**ELECTRONIC REPORT TO GEORGES RIVER LOCAL PLANNING PANEL
FOLLOWING DEFERRAL OF 20 JUNE 2019**

Development Application No	DA2018/0462
Site Address & Ward Locality	87 Woronora Parade Oatley Mortdale Ward
Proposed Development	Demolition works and construction of detached dual occupancy with swimming pool for each dwelling
Owners	365 Project Management Pty Ltd
Applicant	J Chen
Planner/Architect	ARC Homes Australia
Date of Lodgement	6/11/2018
Submissions	28
Cost of Works	\$740,000.00
Local Planning Panel Criteria	The development has received more than 10 unique submissions by way of objection.
List of all relevant s.4.15 matters (formerly s79C(1)(a))	State Environmental Planning Policy No 55 – Remediation of Land, State Environmental Planning Policy (Building Sustainability Index: BASIX) 2004, State Environmental Planning Policy (Vegetation in Non-Rural Areas) 2017, Deemed State Environmental Planning Policy – Georges River Catchment, Hurstville Local Environmental Plan (HLEP) 2012, Hurstville Development Control Plan No 1 - LGA Wide

List all documents submitted with this report for the Panel's consideration	Amended Architectural Plans; Amended Landscape Plan; Driveway Assessment; A

Figure 1: Elevational Shadow Diagram 9/10am 89 Woronora Parade (Source: ARC Homes)

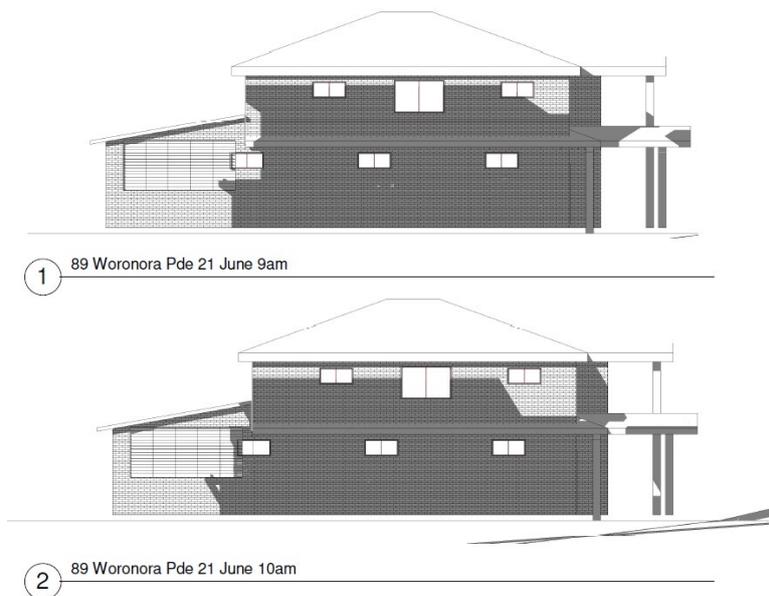
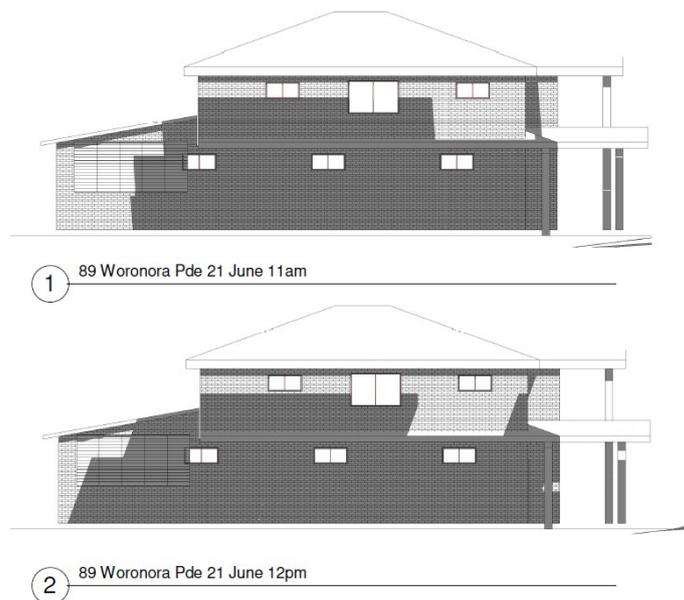
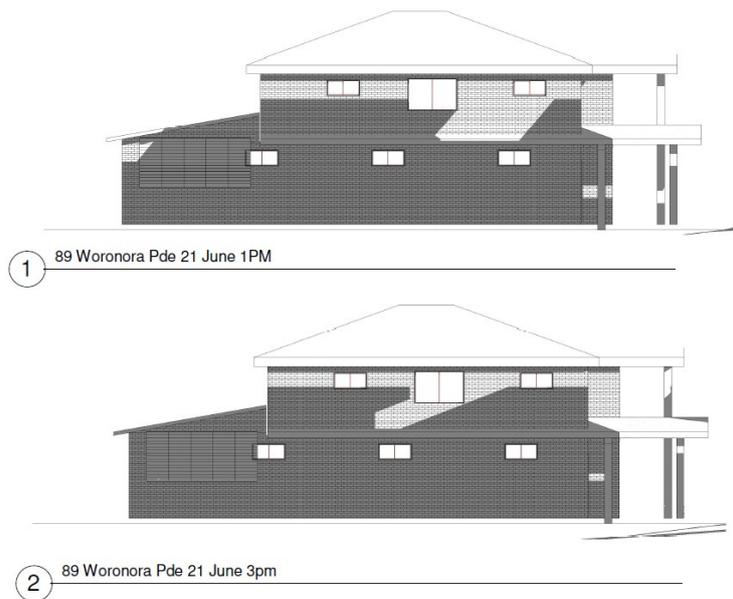
19. In addition, three (3) ground floor windows including one (1) lounge room window and one (1) dining room window in the northern side of the southern adjoining property does not receive 3hrs of sunlight on 21 June (refer to Figures 1-3 below).

However, in this case, the exemption clause cannot be invoked as the development contains various non-compliances, including building height non-compliances, which result in increased overshadowing. The overshadowing could be reduced with a more conservative design.
